PCN – Process Change Notification

Change:	OMB.433.B06F21
Date:	2016/07/12
Author	Kim Ho

Model#	Part Number	Changes
433MHz 6dBi Omni Antenna with N Type Female,U Bolt 1473mm Length Ø70*55mm	OMB.433.B06F21	Amend Aluminium tube brackets.
		Amend length.

Old drawing

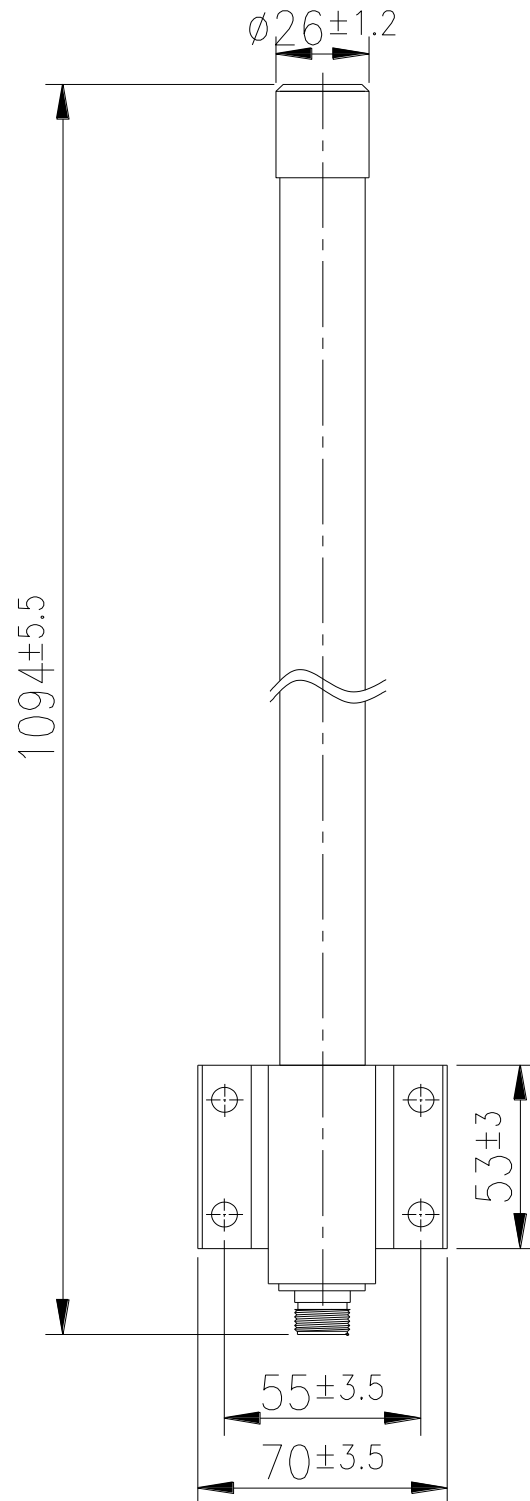
1. Due to antenna performance, Aluminium tube brackets size need to amend from 53mm to 73mm, also change length from 1094mm to 1473mm.
